January 24, 1992  
LD-92-006

Docket No. 52-002

Subject: Response to NRC Requests for Additional Information

RESPONSE TO NRC REQUESTS FOR ADDITIONAL INFORMATION  
PLANT SYSTEMS BRANCH

Figure  
9.2.2-1

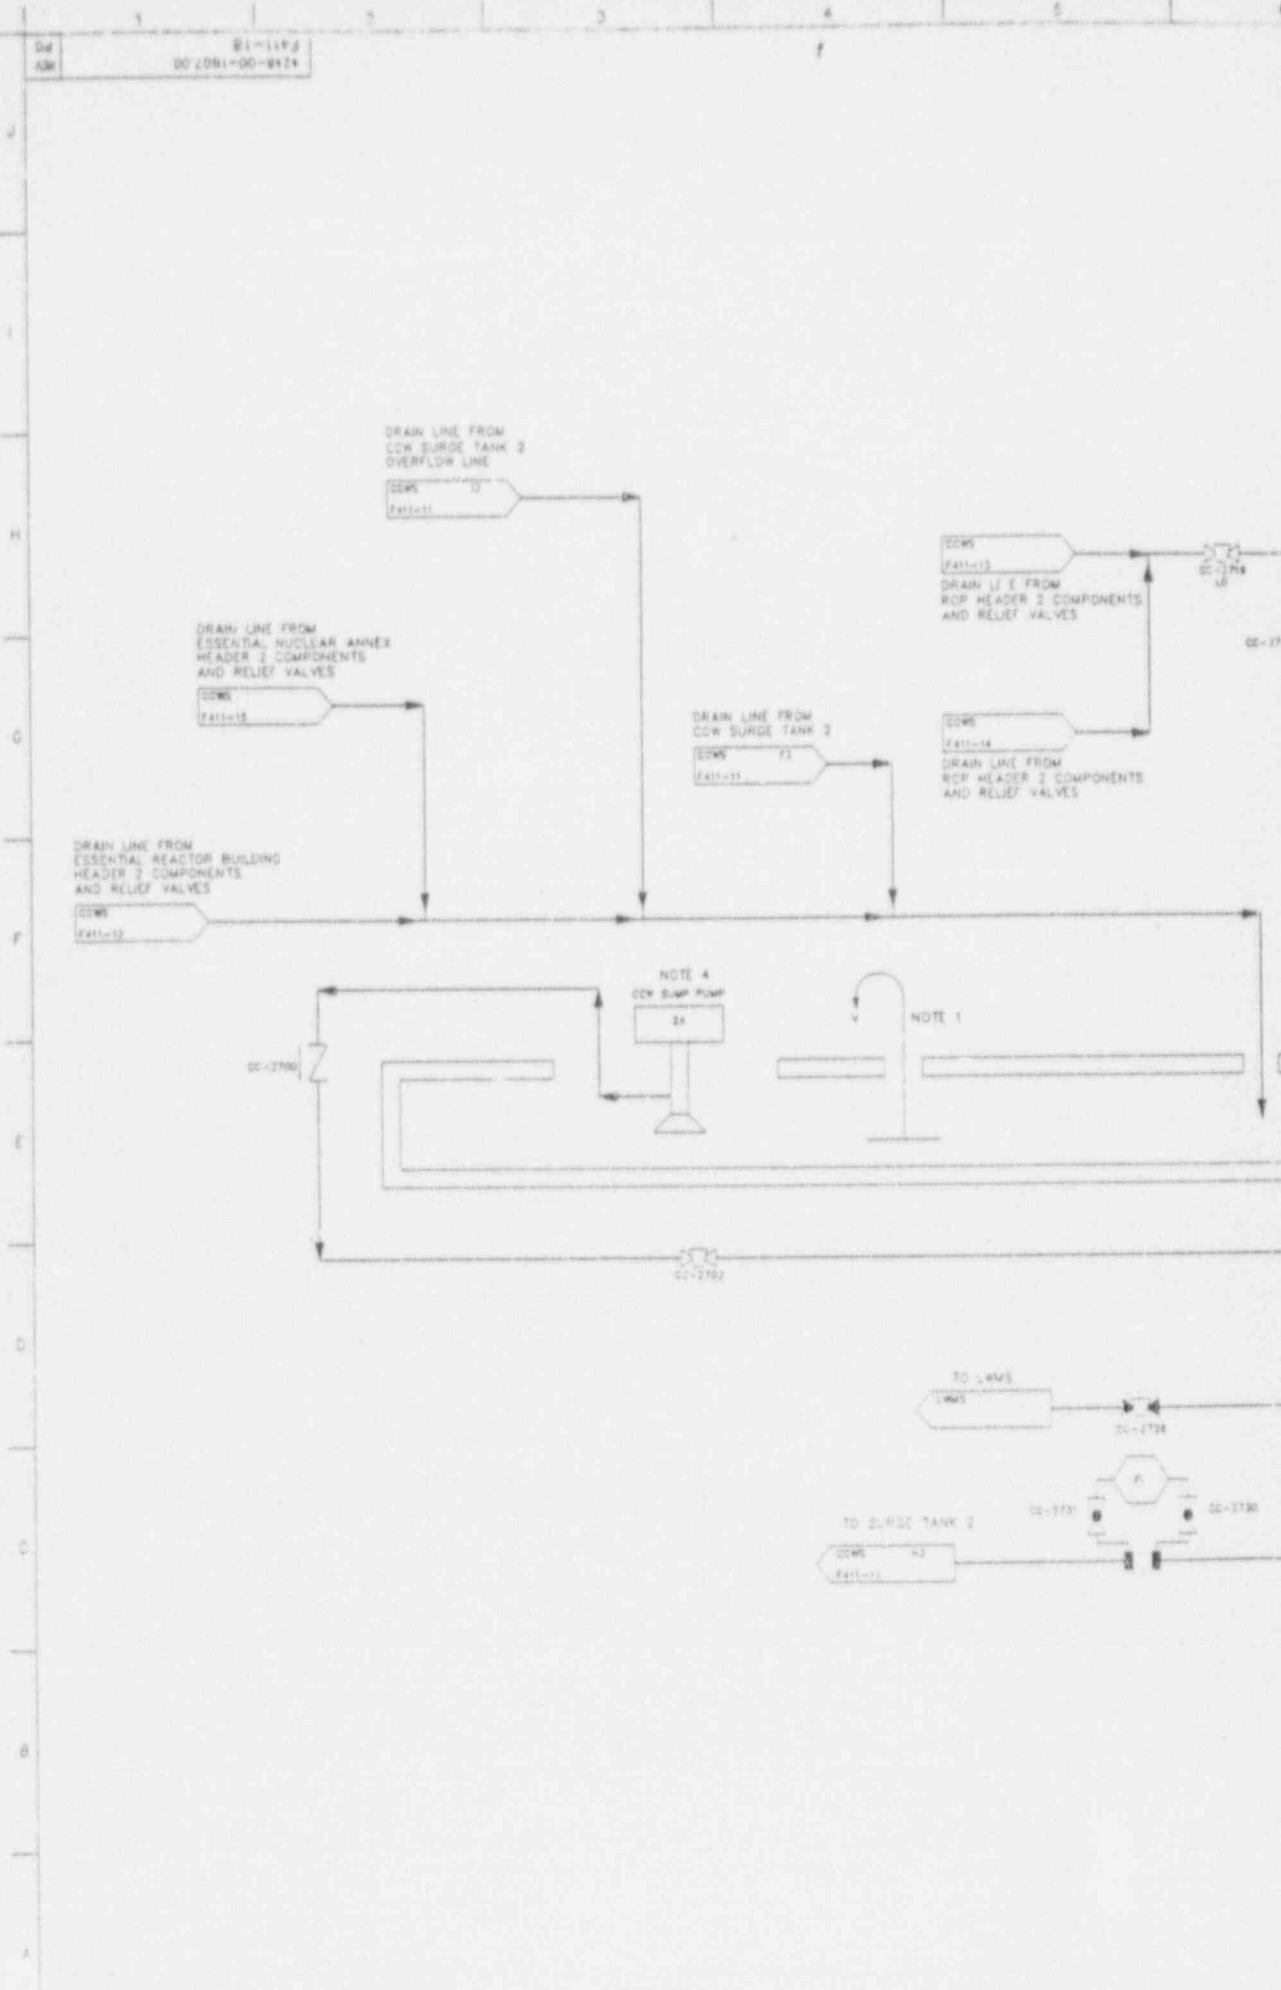
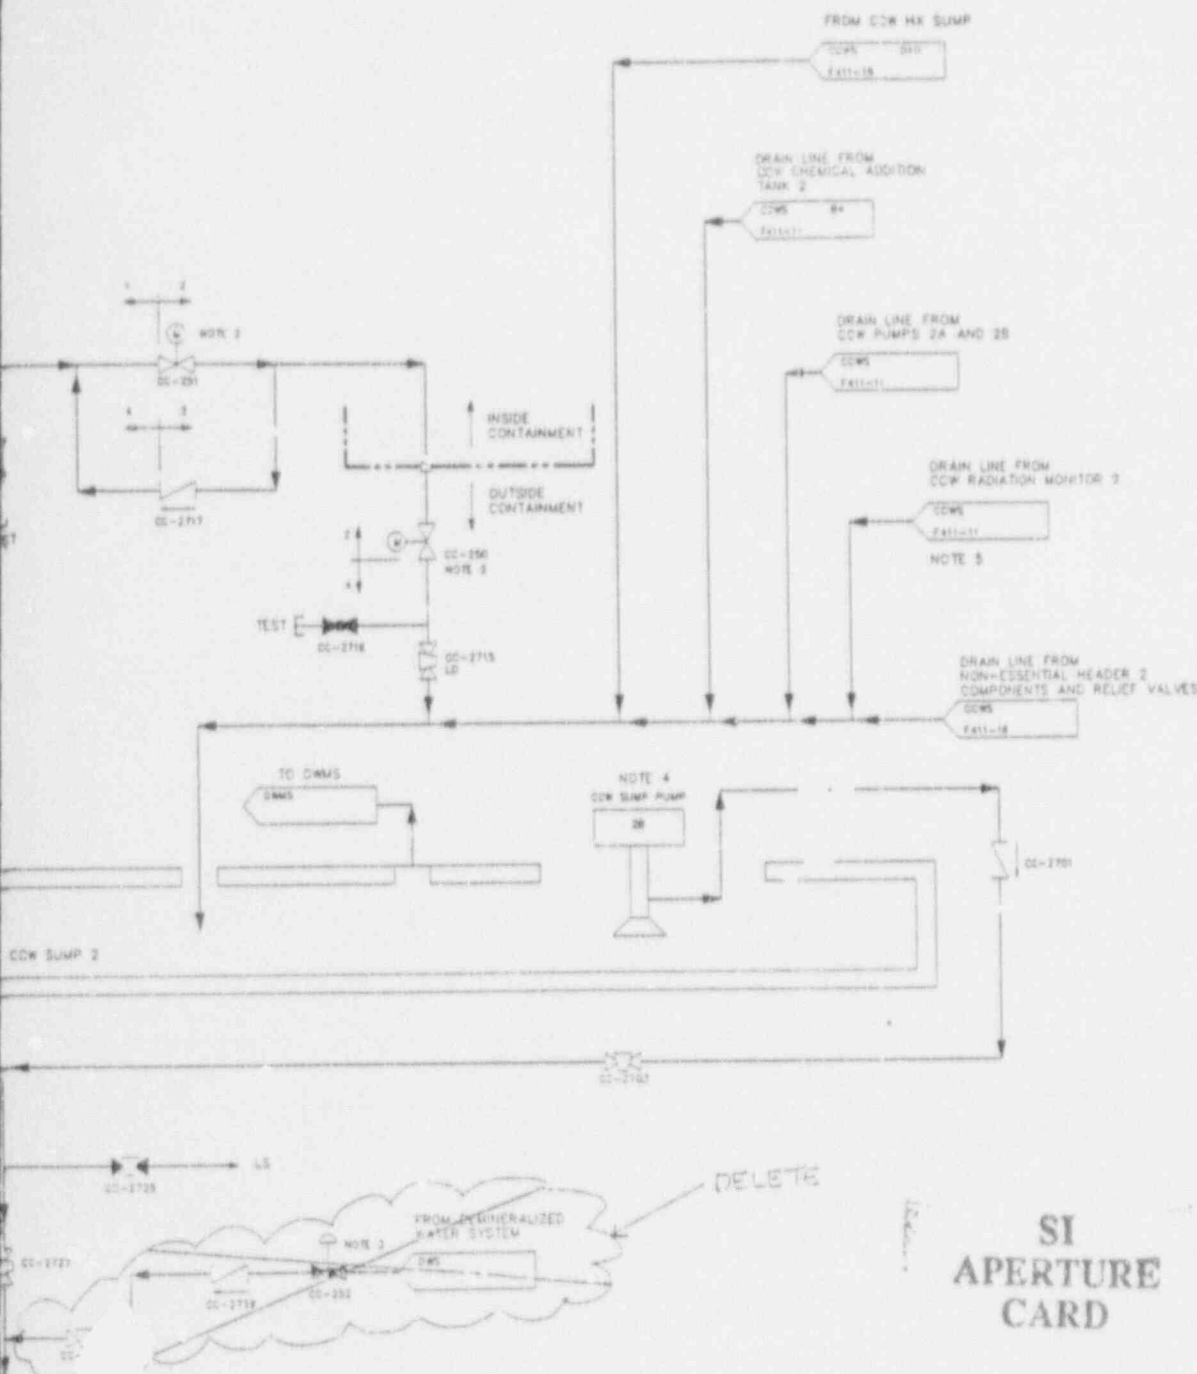
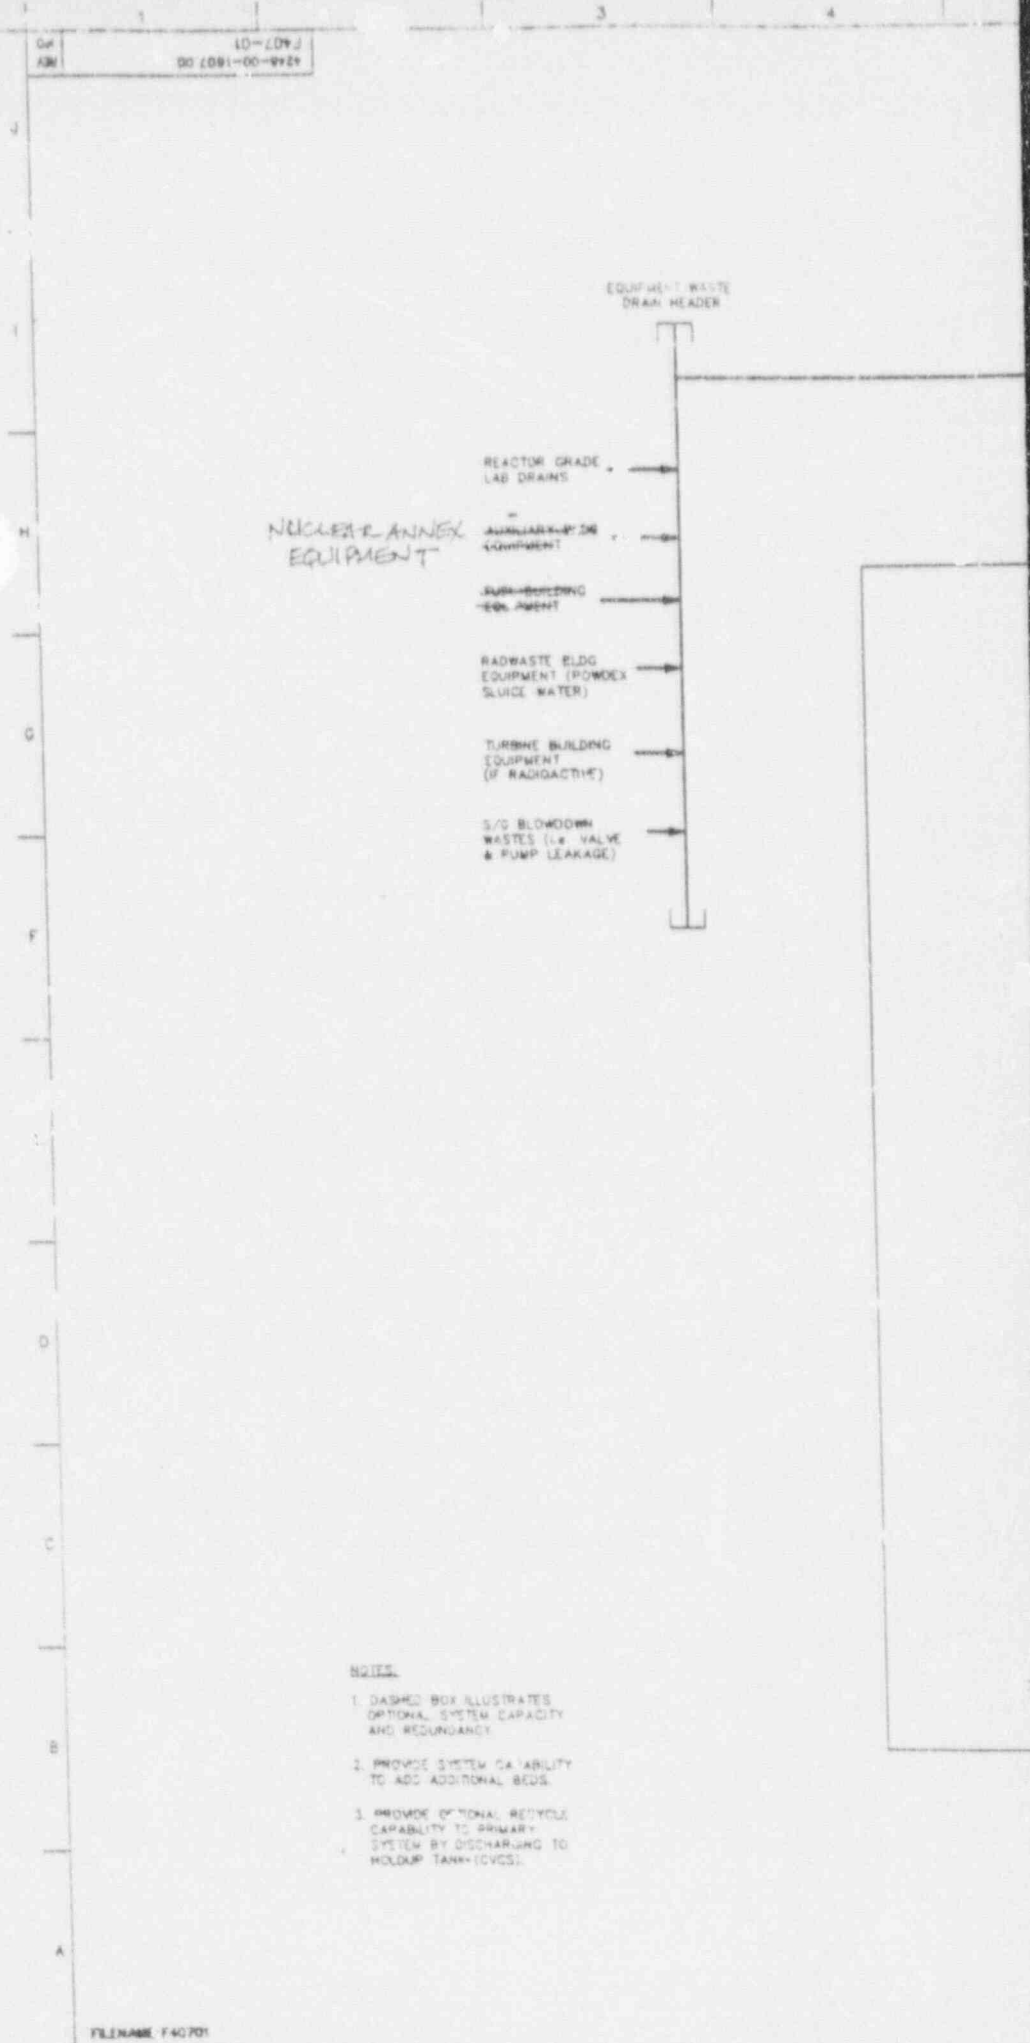
- e. Table 9.2.2-4 should be revised to identify the design volume of the surge tanks to allow for an evaluation of the adequacy of this volume.
- f. Figure 9.2.2-1 should also be revised to identify the interface between the CCWS and the Demineralized Water System. While the Demineralized Water system is the primary makeup system, it is not reflected on the CESSAR figures.

This response is being incorporated into CESSAR-DC Section 9.2.2, "Component Cooling Water System." The line is being moved to a higher point on the surge tanks on Sheet 1 and Sheet 11 of Figure 9.2.2-1 to better reflect its relative position. Also, this response is reflected as a note addition on Sheet 1 and Sheet 11 of Figure 9.2.2-1. Markups of Sheet 1 and Sheet 11 of Figure 9.2.2-1 are attached for NRC review.

- f. The Demineralized Water Makeup System (DWMS) makeup to the Component Cooling Water Surge tanks is reflected on Sheet 17 and Sheet 18 of Figure 9.2.2-1. The line for DWMS makeup to the CCWS is being moved to Sheet 1 and Sheet 11 of Figure 9.2.2-1 to better reflect normal makeup to the surge tanks.

This response is being incorporated into CESSAR-DC Section 9.2.2, "Component Cooling Water System." The response is reflected as the removal of the DWMS connection from Sheet 17 and Sheet 18 and the addition of the DWMS connection on Sheet 1 and Sheet 11, respectively. Markups of Sheet 1, Sheet 11, Sheet 17, and Sheet 18 are provided for NRC review.

This response is being incorporated into CESSAR-DC Section 9.2.2, "Component Cooling Water System." The radiation monitors are being relocated to allow their use during all modes of system operation (See Sheet 1 and Sheet 11 of Figure 9.2.2-1). Section 9.2.2.2.1.7, "Component Cooling Water Radiation Monitors," and Section 9.2.2.5.5, "Radiation Monitors," are also being revised to reflect this change. Markups of Figure 9.2.2-1 (Sheet 1 and Sheet 11) and Sections 9.2.2.2.1.7 and 9.2.2.5.5 are provided for NRC review.
